Project Meadow

Project Meadow

URBAN DESIGN PEER REVIEW

09.23.2022

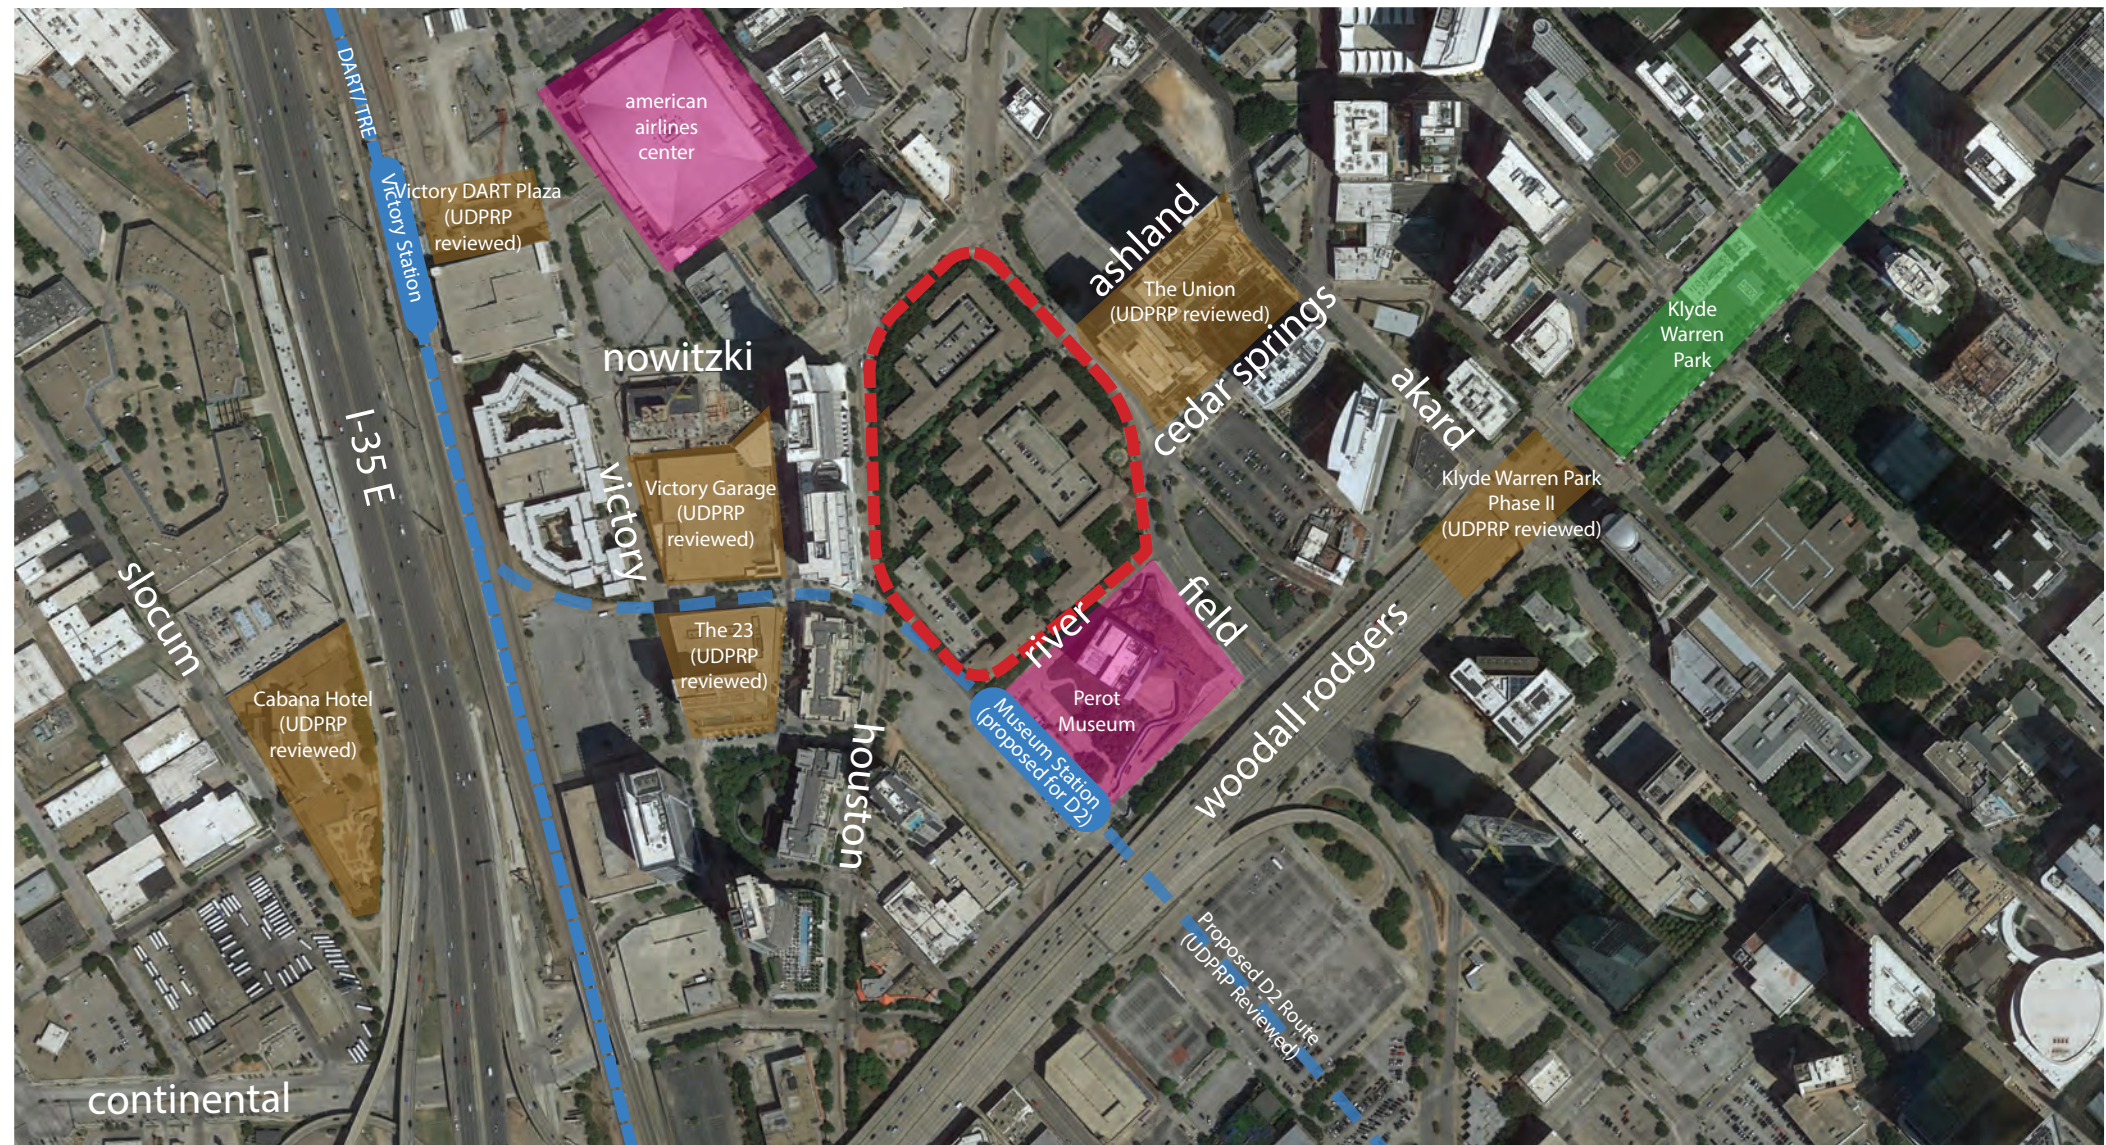
- [1] Consider treatment of the proposed motor court facilitating safe and inviting pedestrian access to the park prioritizing the pedestrian to the greatest extent possible -
The design should consider how the area for vehicles is treated to screen their view from the public realm along Field while providing landscaping and wayfinding to seamlessly connect pedestrians to the internal park.

- [2] Design the Field Street facade to maximize pedestrian comfort and interest-
Understanding that certain parking and back-of-house uses are required and will be located along street-facing facades, the design team should maximize opportunities for enhance landscaping, facade design, and other elements to create a pleasant and uniform pedestrian experience along the South Tower Field Street facade. The development team should also work to screen the loading area to the extent possible through landscaping, use of materials, and the driveway's interaction with the sidewalk to provide the best pedestrian experience possible.

- [3] Ensure seamless interaction between the building and the internal park -
The proposed park will be the heart of the proposed development. Ensuring an inviting and engaging experience between the ground-level retail, tenant, and courtyard spaces and the park will be important in providing a rich and engaging edge to the park.

- [4] Create a safe and uniform pedestrian experience across all driveways and parking garage entries -
The streetscape on all sides of the development should provide generous sidewalks that prioritize the pedestrian. Crossings of major vehicular entries into the site, including parking garages and loading bays, should be designed to prioritize pedestrian mobility as this site is highly transit-oriented and walkable.
